**PARK CITY MUNICIPAL CORPORATION
HISTORIC PRESERVATION BOARD
COUNCIL CHAMBERS, CITY HALL
MAY 29, 2012 - 5:30 PM**

335 Woodside Avenue – Appeal of Design Review

Historic Preservation Board Staff Report

Subject: 335 Woodside Avenue
Author: Francisco Astorga
Date: May 29, 2012
Type of Item: Quasi-Judicial – Appeal of Staff’s Determination of Compliance with the Design Guidelines for Historic Districts and Historic Sites

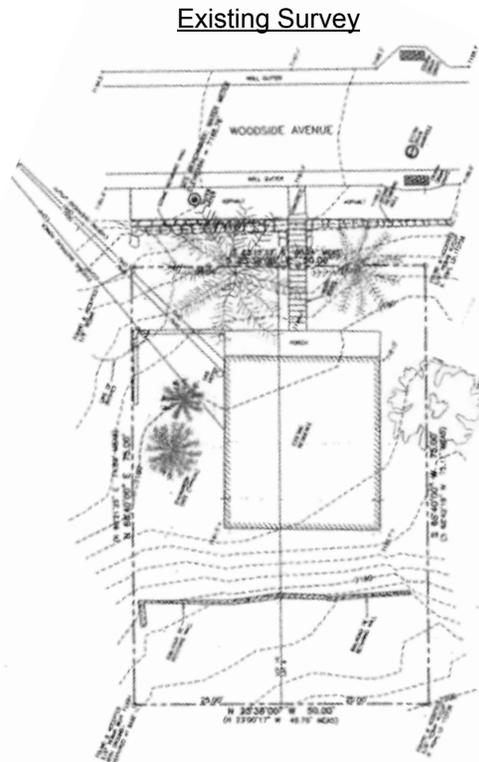
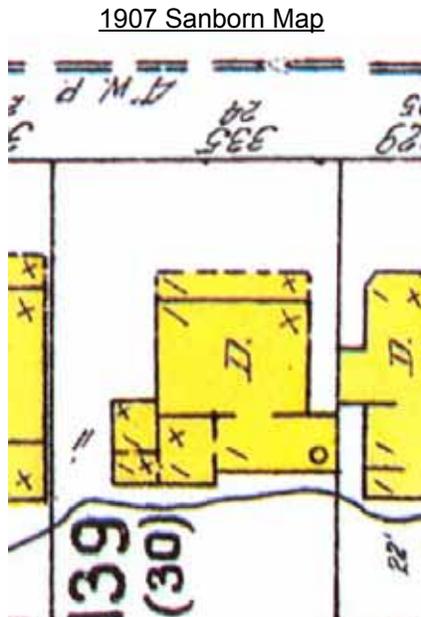
The appellant raised the following objections related to removal of the nearly four and a half feet (4.5') rear portion of the existing structure in the appeal:

- *Material-concept of integrity*
- *Footprint shown on the Sanborn Fire Insurance Maps*
- *Universal Guideline no. 3.*

The rear wall was scheduled to be removed because it has been determined to be part of a non-contributory footprint/addition. The Sanborn maps of 1900, 1907, 1929, 1940, and 1958¹ indicate the same exterior configuration, see Exhibit C, also illustrated in the 1907 Sanborn map shown below to the left. This configuration shows the footprint of the front half to remain unchanged in its square form with the porch covering the entire length of the front façade. However the rear half of the structure is completely different from what exists today. See existing survey map shown below to the right, also found on Exhibit B – approved plans. The illustrations below are not to scale as the purpose of the illustrations is to show the difference in footprint.

As shown on the historic and existing footprints above, one can clearly identify that the rear façade is completely different as the historic footprint has a small change in the rear wall plane. In addition, the historic footprint shows that the rear portions of both sides have respective bump-out features extending past the side façades which were removed after 1958.

Exhibit C - Sanborn Maps

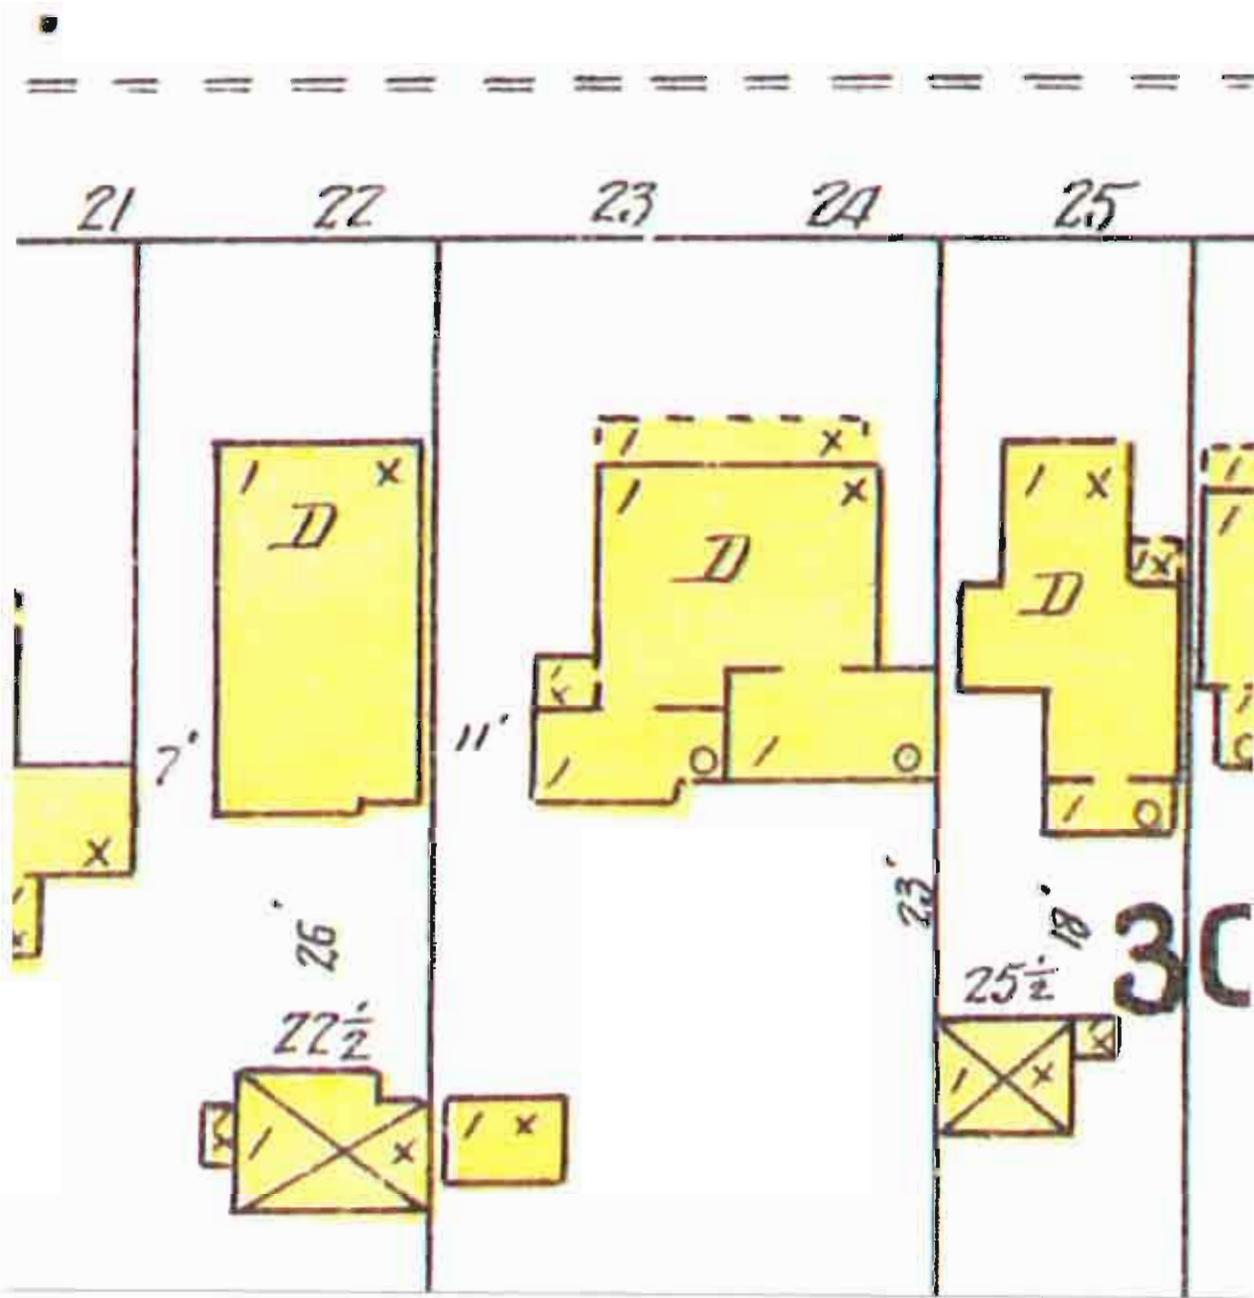
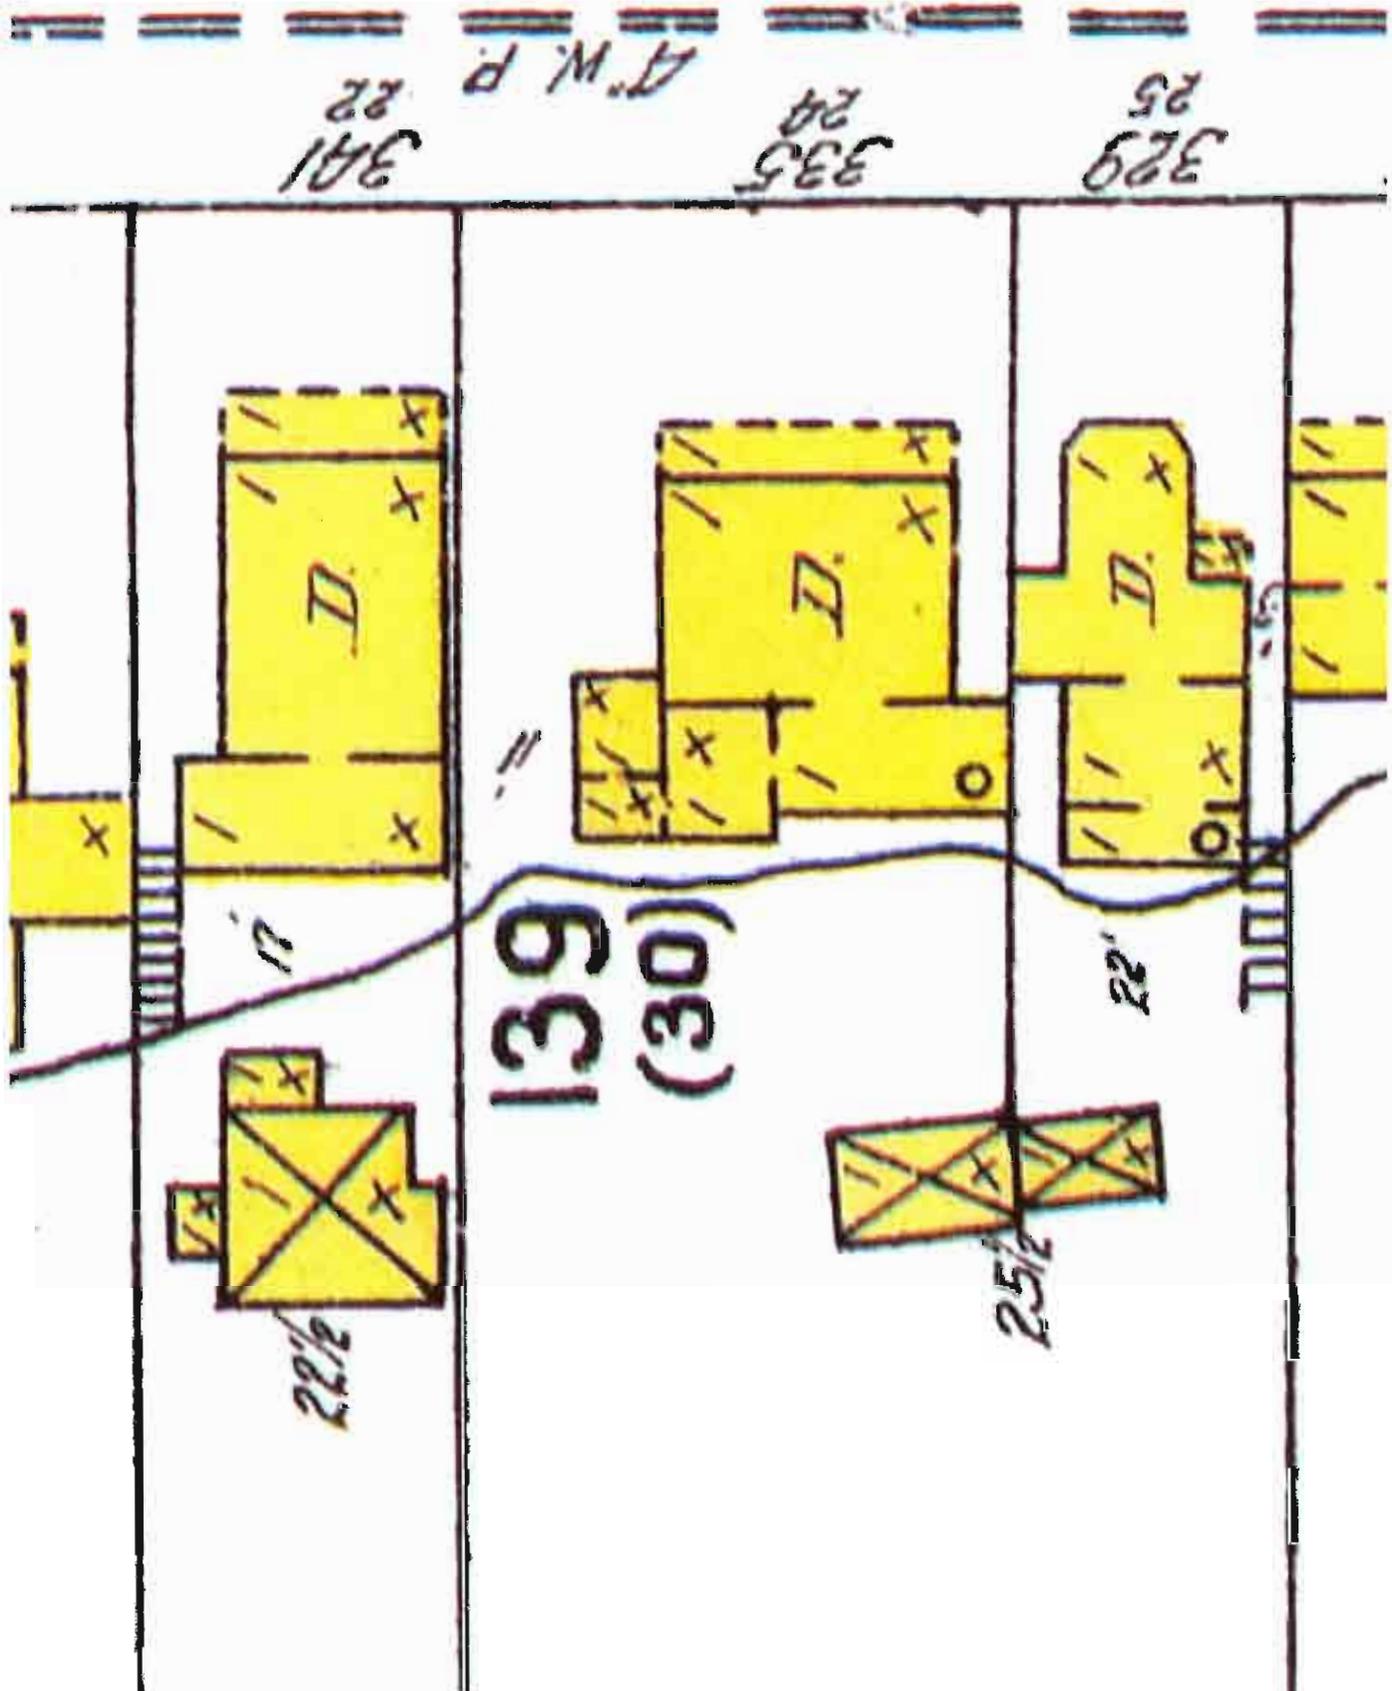
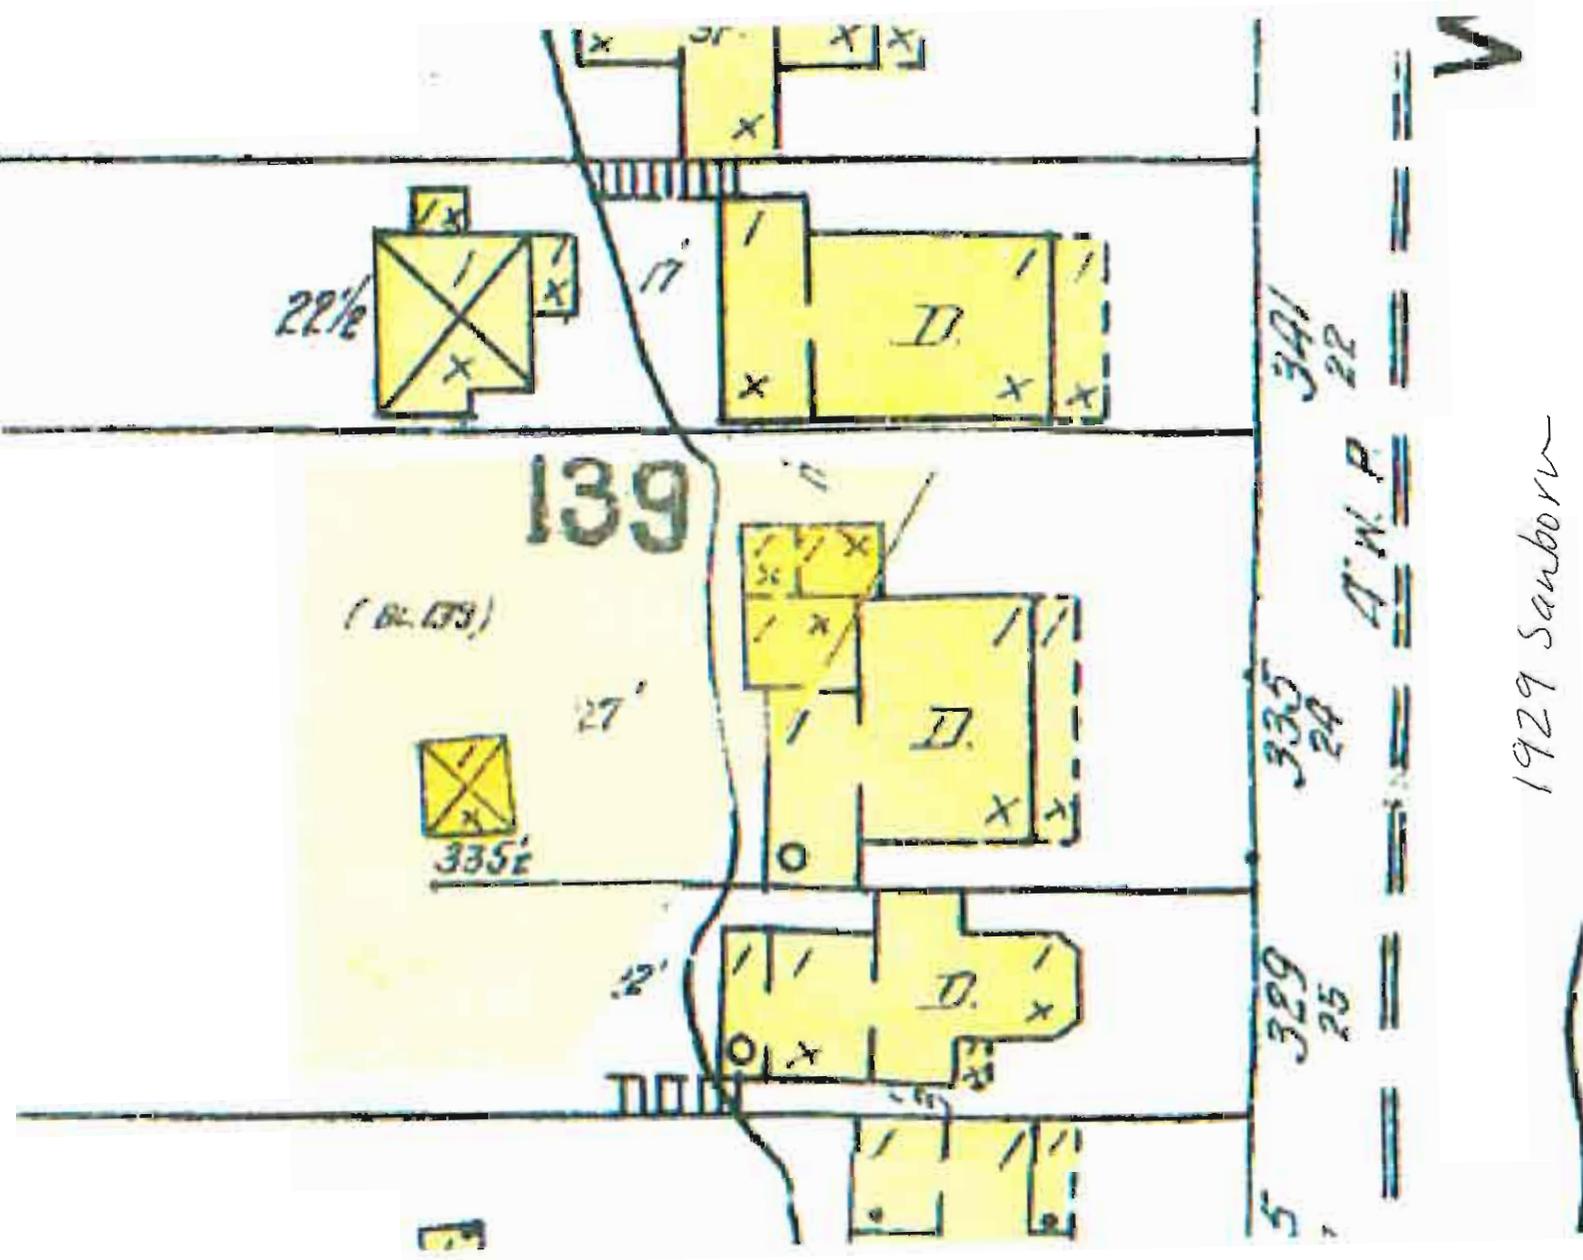
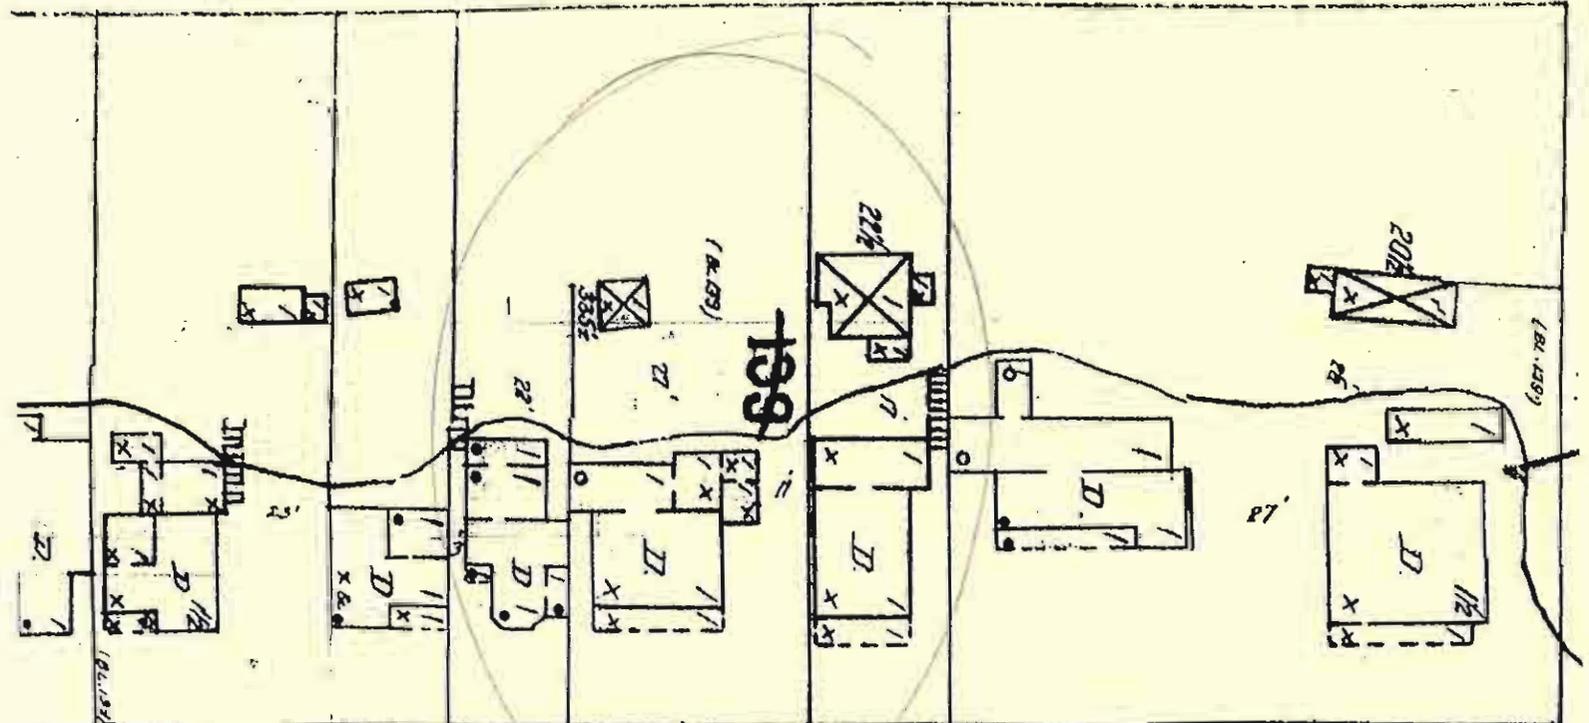
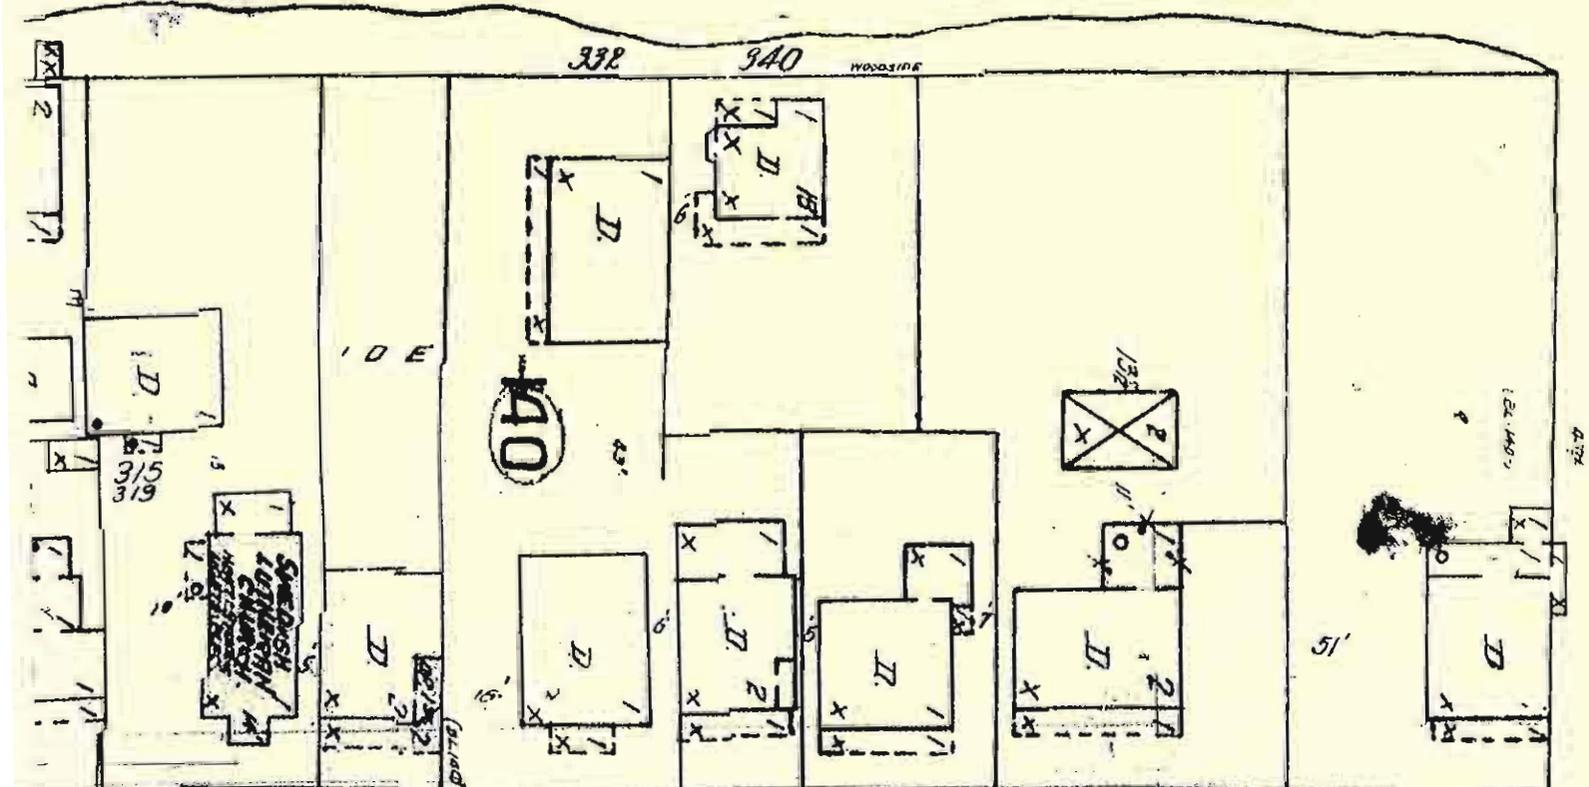
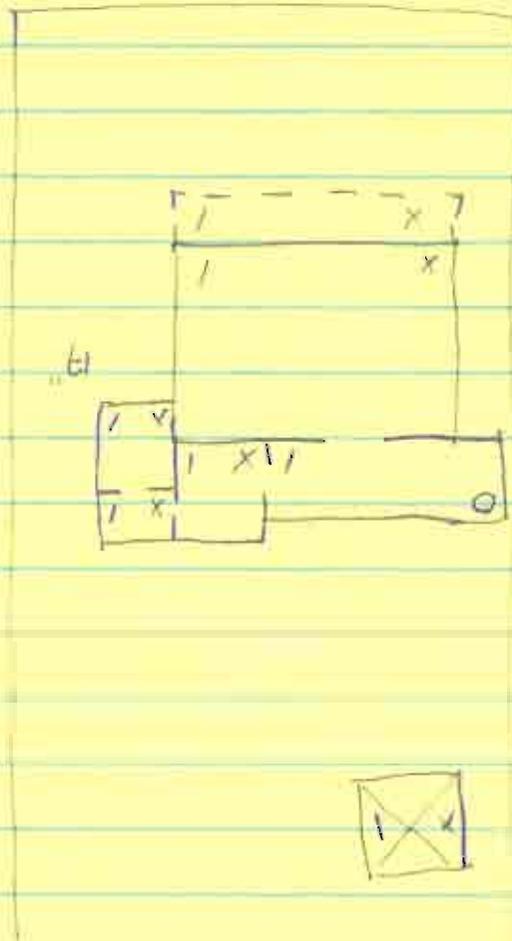
The mass of 335 Woodside with regard to the footprint (horizontal mass) as it existed at the turn of the last century is manifest in both the 1900 and 1907 Sanborn Insurance maps. The

structure's footprint as it appears today matches the Sanborn maps when evaluated in terms of horizontal mass with regard to the placement of the structure as it sits on the lot; front, back and side yard setbacks of the main structure as shown in the applicant's Dimensioned Site Plan resemble the same placement of the main structure in the Sanborn maps. If the west portion of the structure is removed the new backyard setback will be come greater; there will no longer be a similarity in footprints between the Dimensioned Site Plan and the Sanborn maps.

When the form, or dimensions, of the Sanborn maps footprint are compared to the dimensions of the Dimensioned Site Plan footprint, the current form is, again, similar to the 1900 and 1907 form where the main structure is slightly *deeper than it is wide*. If the back portion is removed from 335 Woodside, then the form of the new footprint will no longer match the proportions of the footprint on the Sanborn maps; the structure would become slightly *wider than it is deep*.

The footprint analysis of the *Sanborn maps* has been properly applied as this evidence has been utilized to compare the historic configuration to the existing shape and a determination has been made that the existing rear façade currently does not provide historical contribution to the site. Staff finds that *Universal Guideline no. 3* has also been met as the historic exterior features of the building are retained and preserved in
